Stage X9/X10  
Lucas, Ballarat

**Contents and Context Plan and Plant Schedule**

**From:** David Grant  
**Sent:** 20 November 2018 9:42 AM  
**To:** Chloe Moorcroft  
**Subject:** FW: Landscape Plan for Approval - Stage X9/X10, Lucas (PLP/2016/141)  
**Attachments:** LUC-X9X10-LDM-schedules.docx; PLA248-L01-L04\_TP1-Stage X9-X10 Lucas.pdf; PLP2016141 Precinct X Endorsed Landscape Masterplan.pdf; 180516 Precinct X Development Plan version 11-UNAPPROVED.pdf

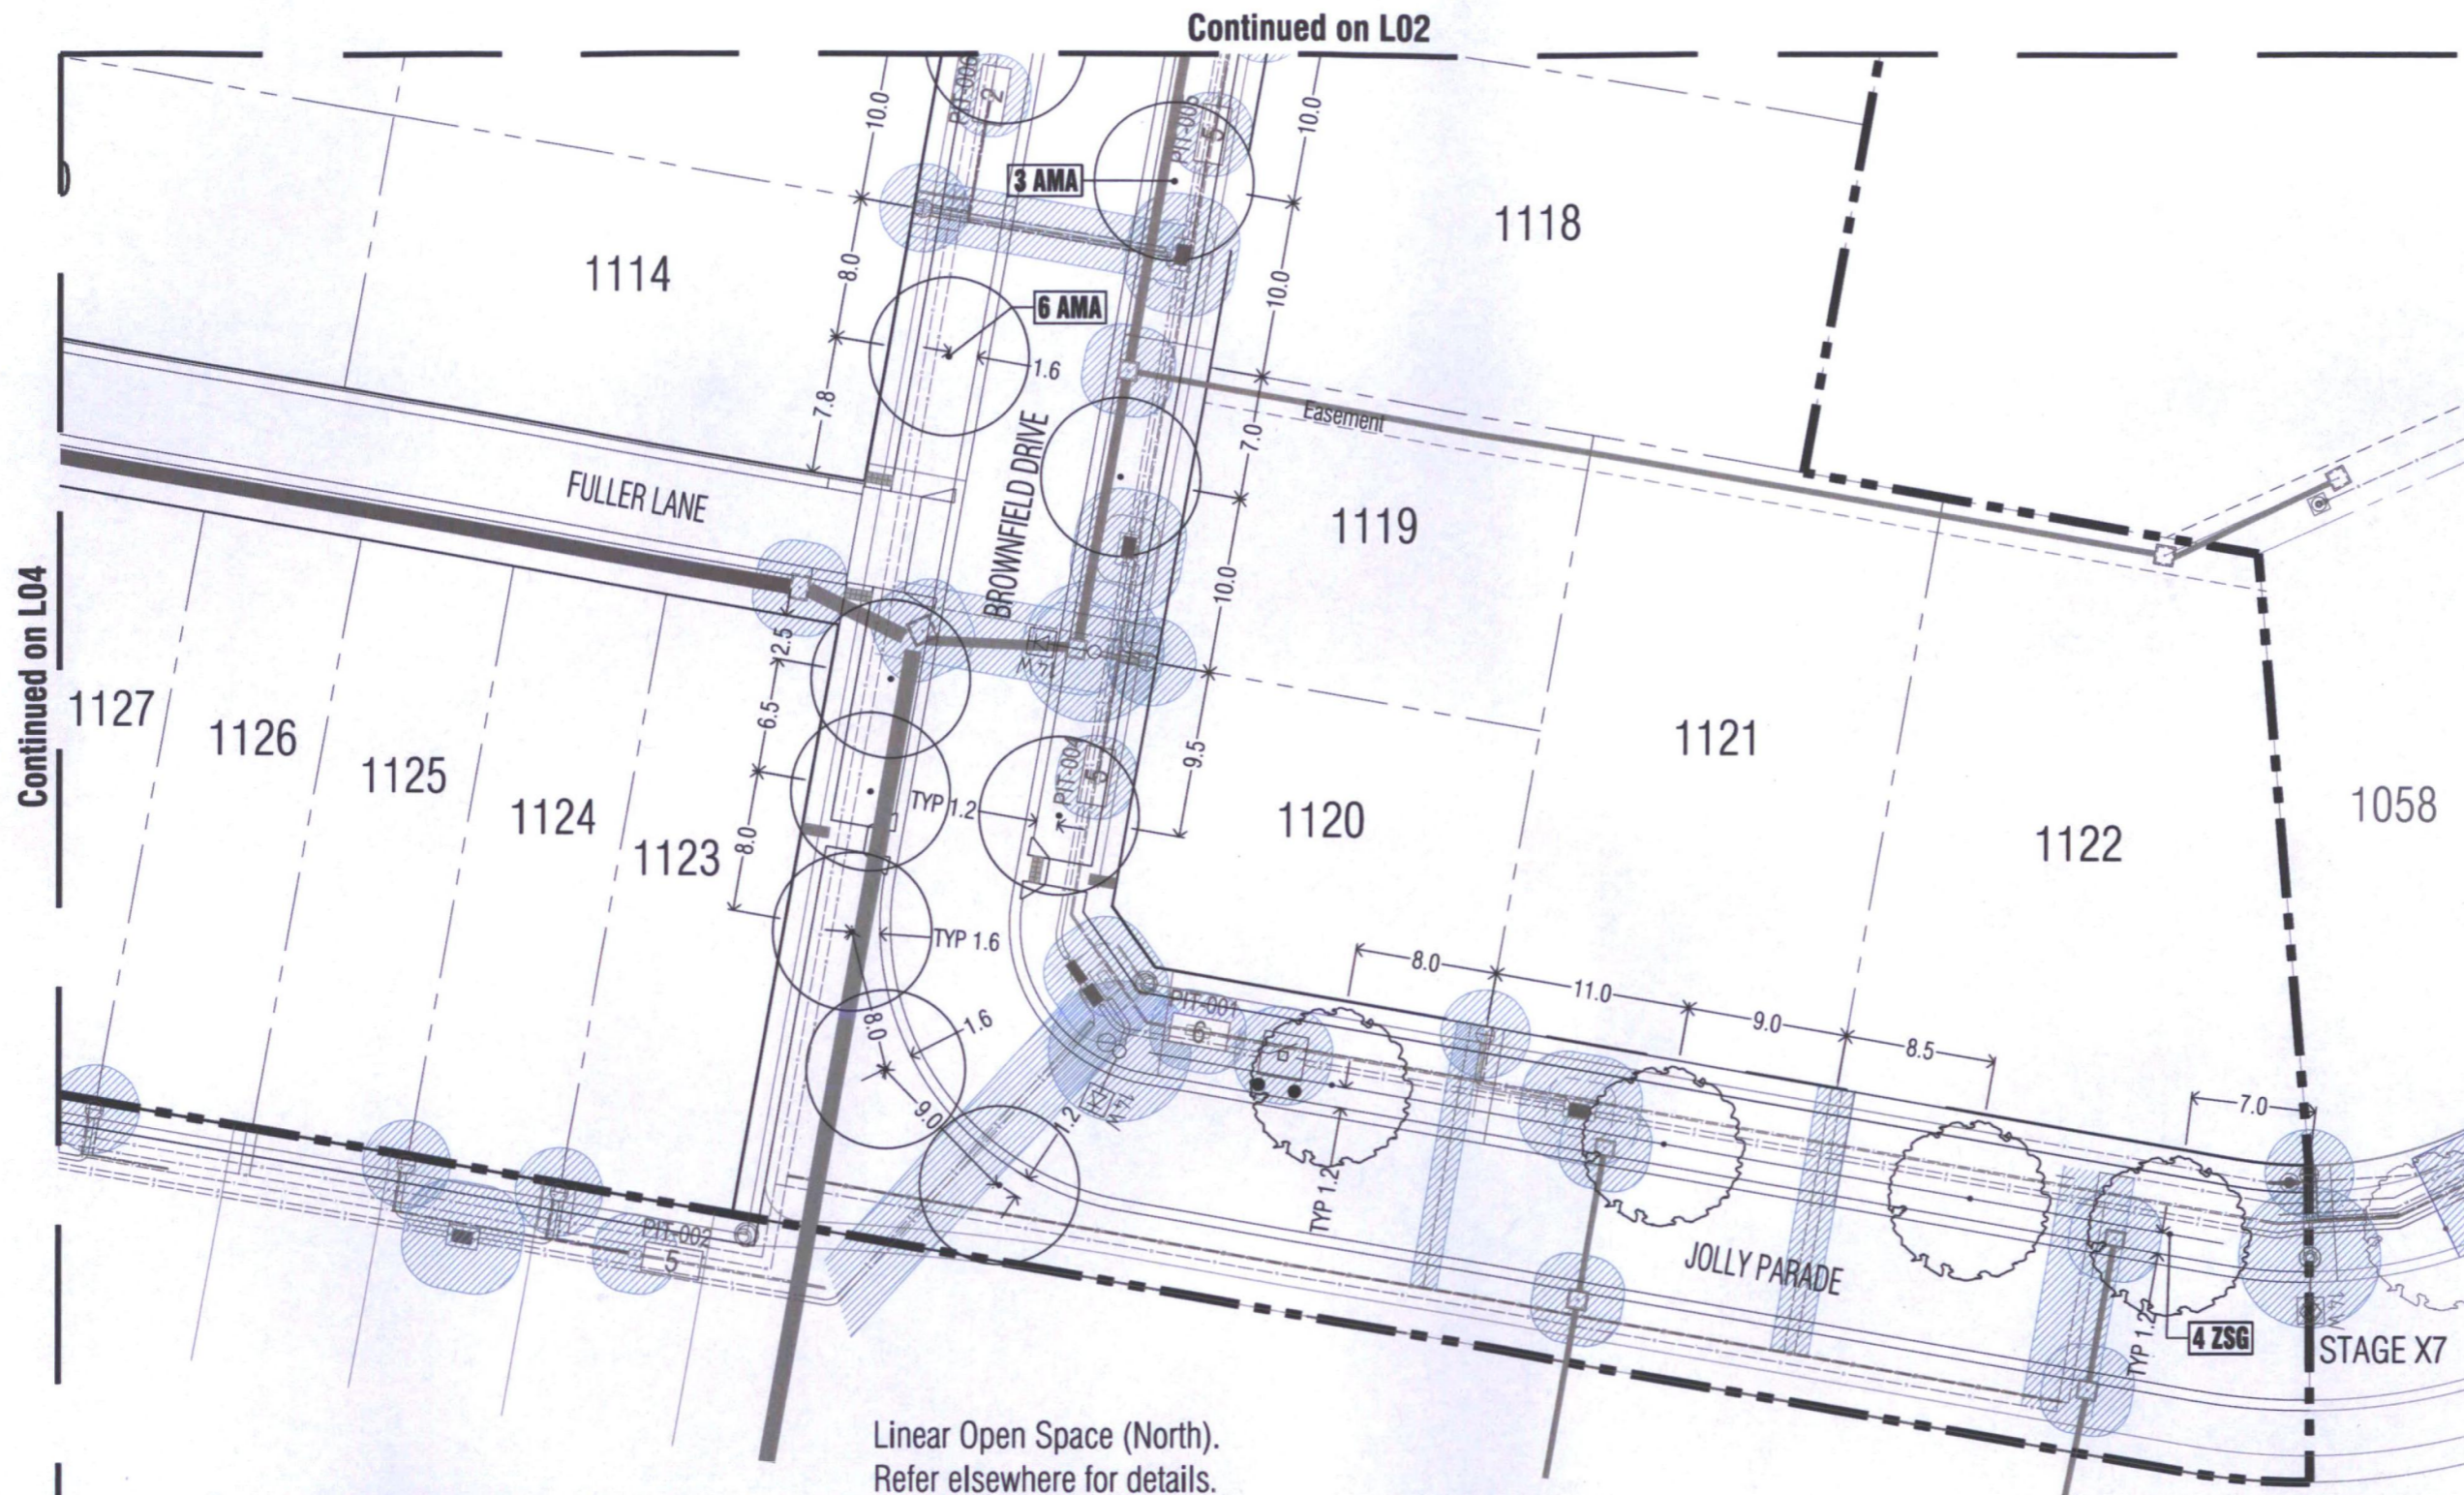
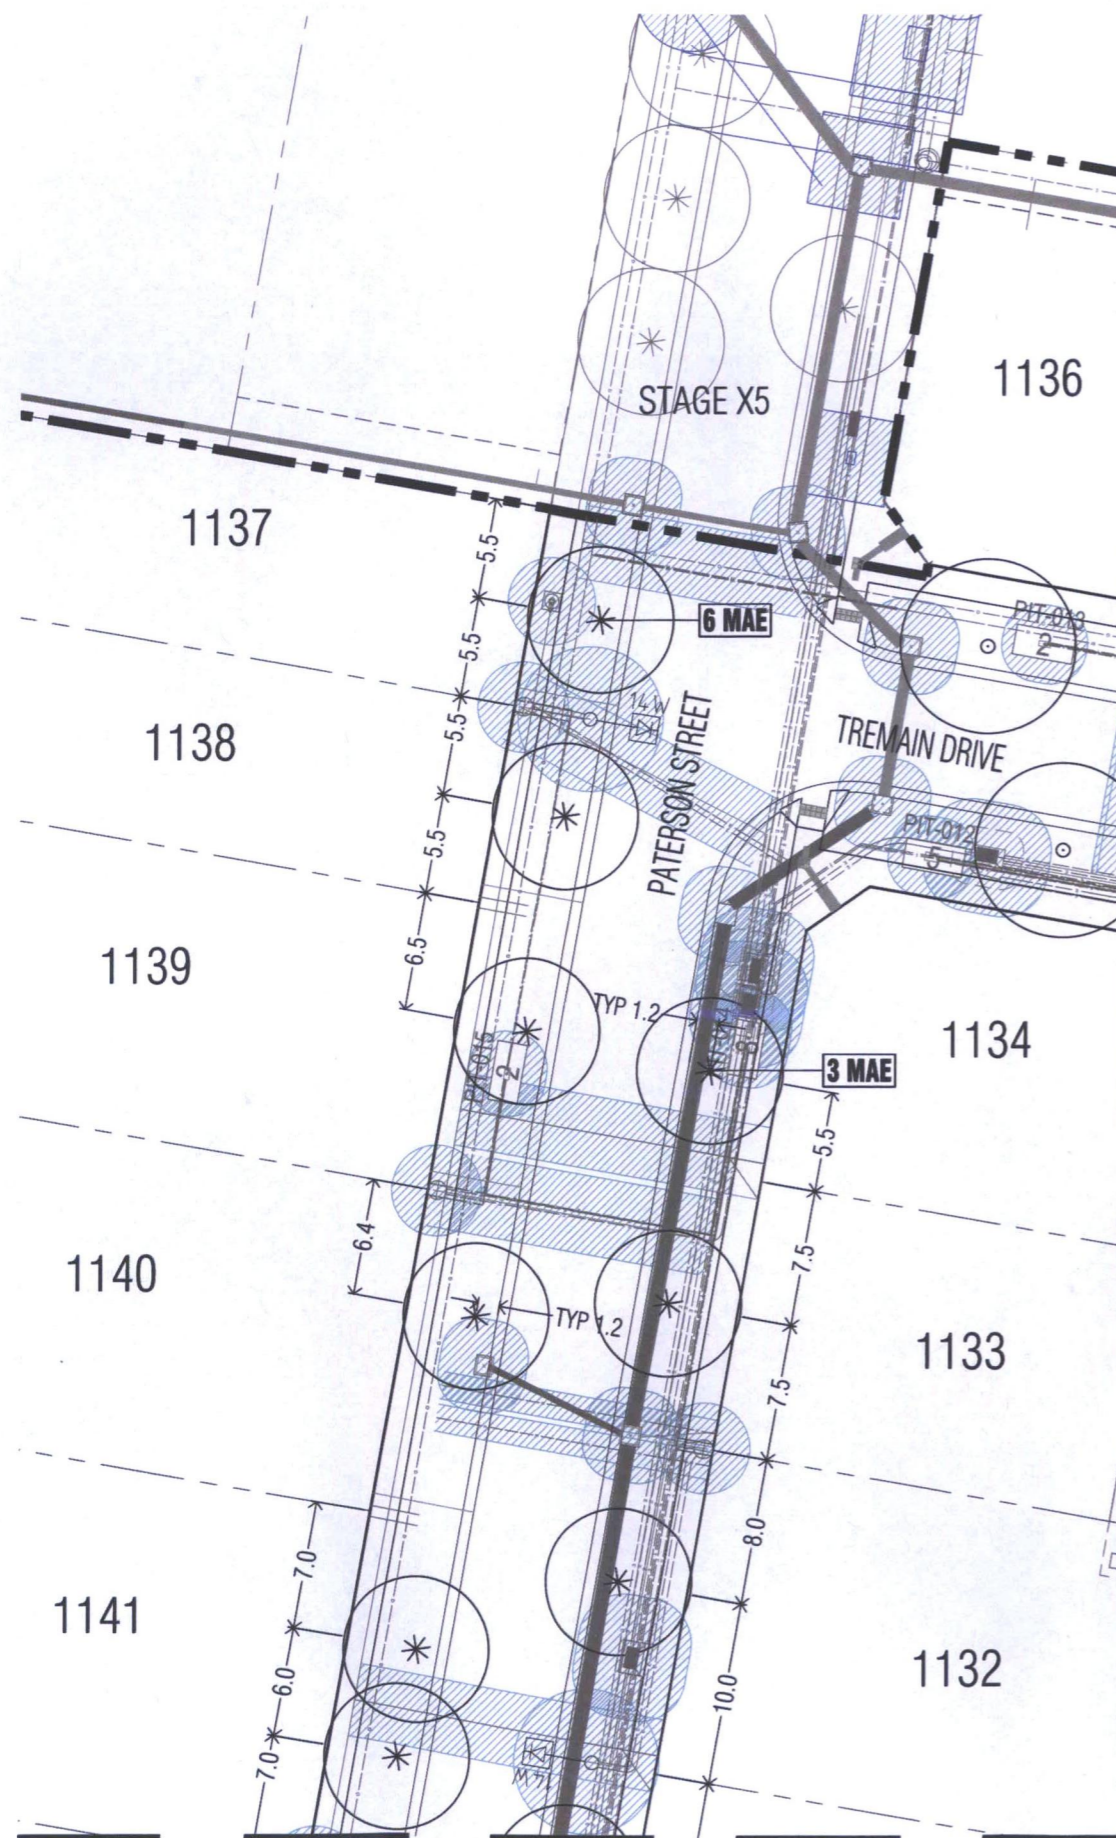
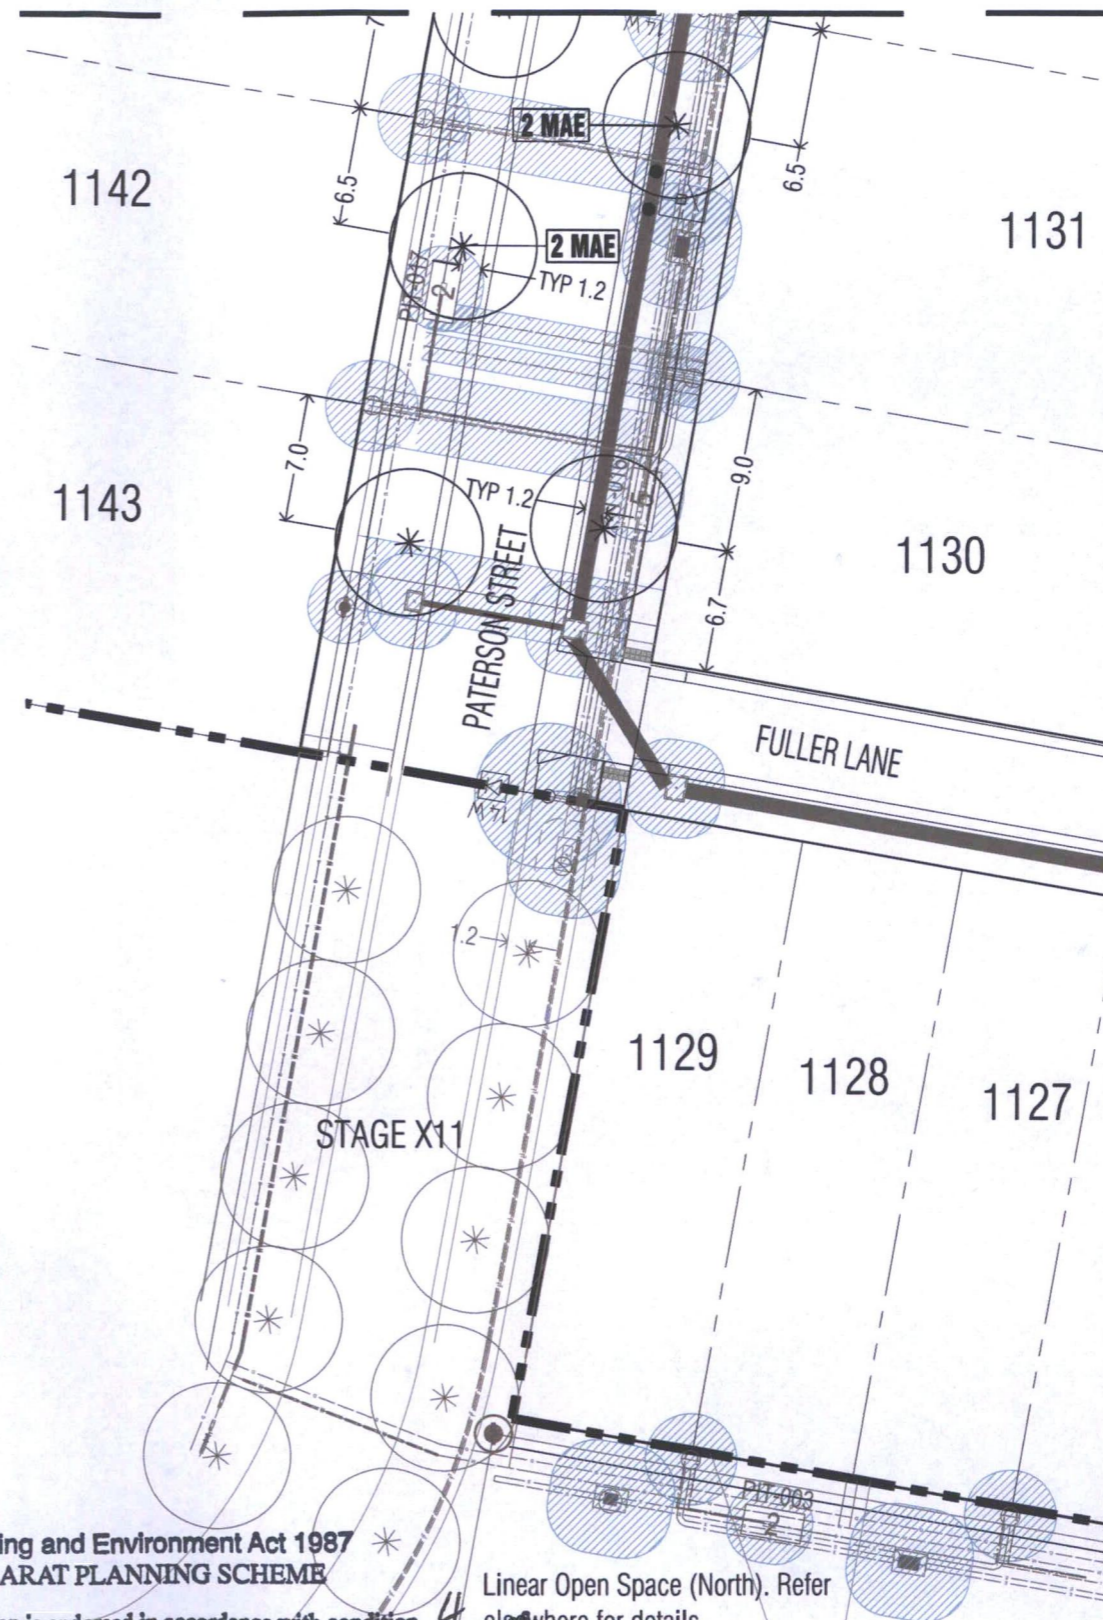
Just had a good look over the plans for Stages X9 and X10. The tree species are correct for each street and the number of street trees is adequate to get near our 40% canopy cover target so I am happy to have these plans endorsed.
